## Burlington Development Review Board

### BURLINGTON DEVELOPMENT REVIEW BOARD Tuesday, October 19, 2021, 5:00 PM PUBLIC HEARING NOTICE

#### AGENDA

**TO:** Development Review Board  
**FROM:** Scott Gustin  
**DATE:** October 19, 2021  
**RE:** ZP-21-655; 162 North Champlain Street

site plan  
1" = 50'

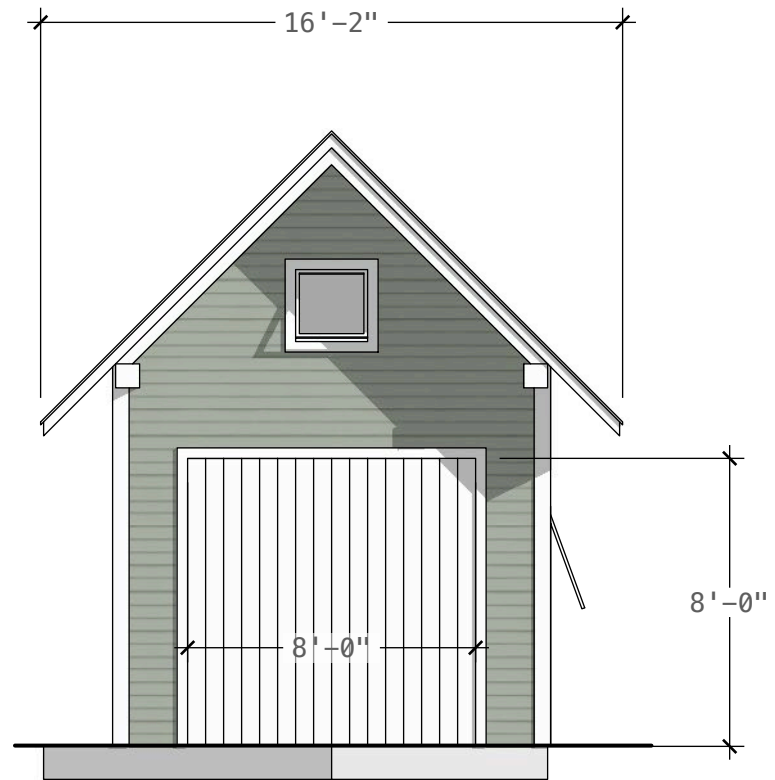
Lot coverage is presently 19.5%. As proposed, it will increase slightly to 21.1%. This increased lot coverage remains below the maximum permissible 40%.

The front yard setback will remain unchanged. The side yard setback will also remain unchanged, except that the proposed garage will have a larger footprint. The existing and proposed setback is 2' or 3' from the nearer side property line. This small setback is acceptable, as the average side yard setback based on the neighboring properties (2 on each side) is 0.' As an accessory structure of less than 15' in height, it may observe a 5' minimum rear yard setback. As proposed, the new garage is 68' from the rear property line.

The proposed garage contains a single bay and has a footprint of 288 sf. The home contains 3 bedrooms and has a ~966 sf footprint. The number of garage bays is limited to the number of bedrooms in the home, and its footprint cannot exceed 75% of the home’s footprint. The proposed garage is compliant in both cases. **(Affirmative finding)**

**west elevation**

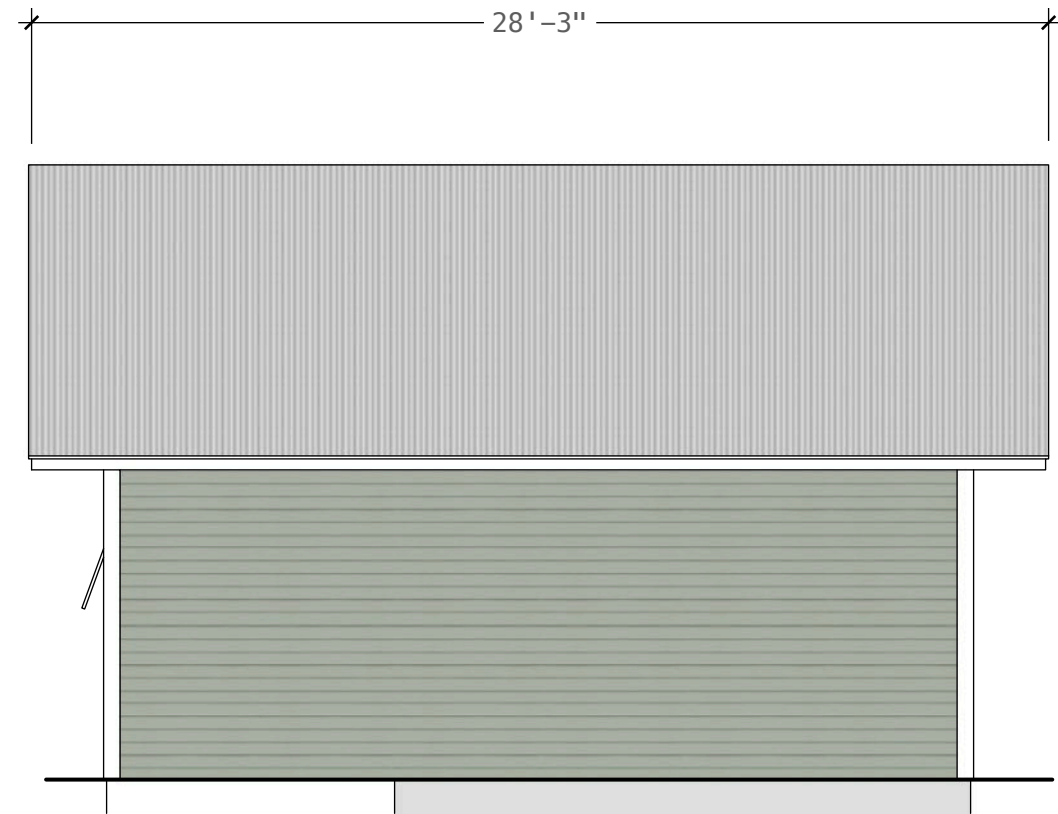
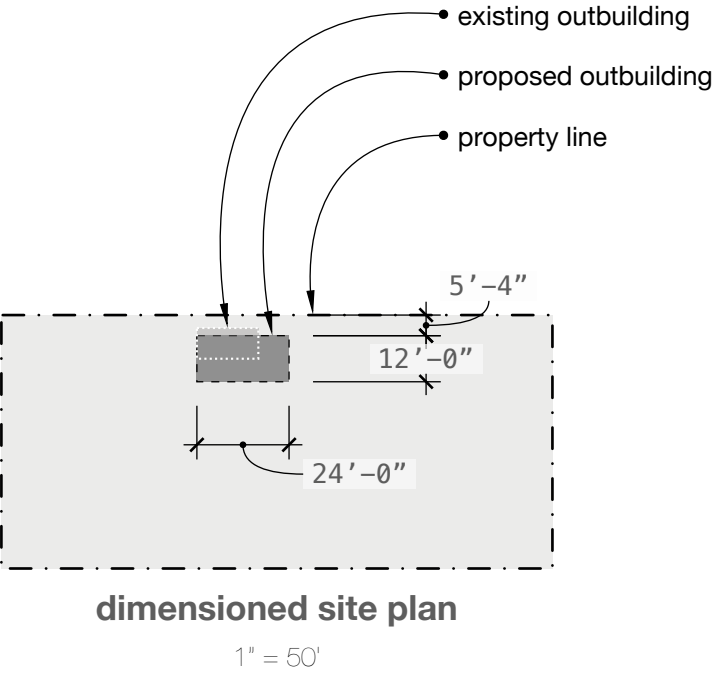
Building height will increase slightly but remains below 15.’ **(Affirmative finding)**
